Indian Point Energy Center
 Document Control
 450 Broadway
 Buchanan, NY 10511

CONTROLLED DOCUMENT TRANSMITTAL

IPEC-EP-19-01 REV.23

IPEC Emergency Plan Revision 19-01 (Rev 23 in eB) REVISION MATRIX

Figure B-1.1 Indian Point Energy Center Station Watch Organization per Unit

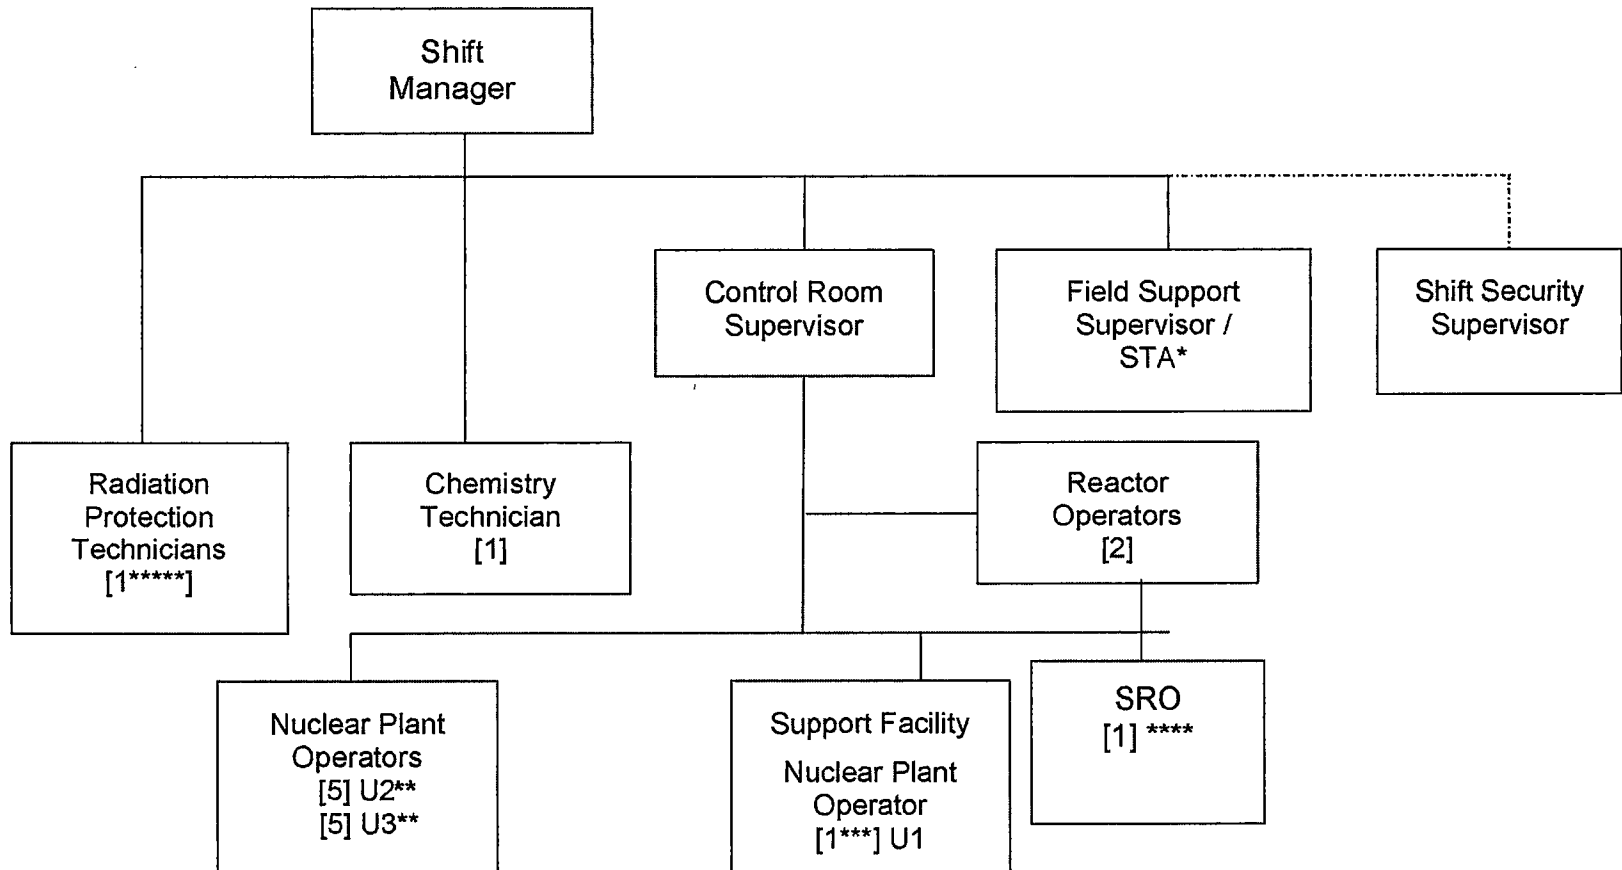
6.	Page B-12, Figure B-1.1	Nuclear Plant Operators [5] U2 [5] U3**	Nuclear Plant Operators [5] U2** [5] U3**	No	Yes- This change adds the ** to the chart which reflects that a Nuclear Plant Operator from Unit 2 or Unit 3 can be the communicator.

7.	Page B-12, Figure B-1.1	SRO [1] U3****	SRO [1]****	No	Yes- This change removes U3 to reflect that a SRO from Unit 2 or Unit 3 can be the Fire Brigade Leader.

8.	Page B-12, Footnote **	One U3 NPO would be the communicator/notifications for both units	One NPO would be the communicator and make notifications for both units	No	Yes- This change removes U3 wording, as the NPO from either Unit 2 or Unit 3 is available to be the communicator and to make the notifications.

9.	Page B-12, Footnote **	One U3 NPO would be the communicator/notifications for both units	One NPO would be the communicator and make notifications for both units	Yes	No – Added the wording “and make”. This corrects a grammatical error in the statement. The meaning or intent of description in the emergency plan, facilities or equipment described in the emergency plan or a process described in the emergency plan are not affected by this change. No further evaluation is required for this change.

10.	Page B-12, Footnote ****	The U3 SRO would serve as FBL for both units	The SRO would serve as FBL for the both units, in accordance with the Fire Protection Program Plan	No	Yes- Deleted U3 wording as the Fire Brigade Leader is available from both Unit 2 and Unit 3. This wording makes it consistent with IPEC's Fire Protection Program Plan.

11.	Page B-12, Footnote ****	The U3 SRO would serve as FBL for both units	The SRO would serve as FBL for the both units, in accordance with the Fire Protection Program Plan	No	No – Added reference to the Fire Protection Program Plan. This added clarification as to where the requirements for the IPEC Fire Brigade reside. The meaning or intent of description in the emergency plan, facilities or equipment described in the emergency plan or a process described in the emergency plan are not affected by this change. No further evaluation is required for this change.
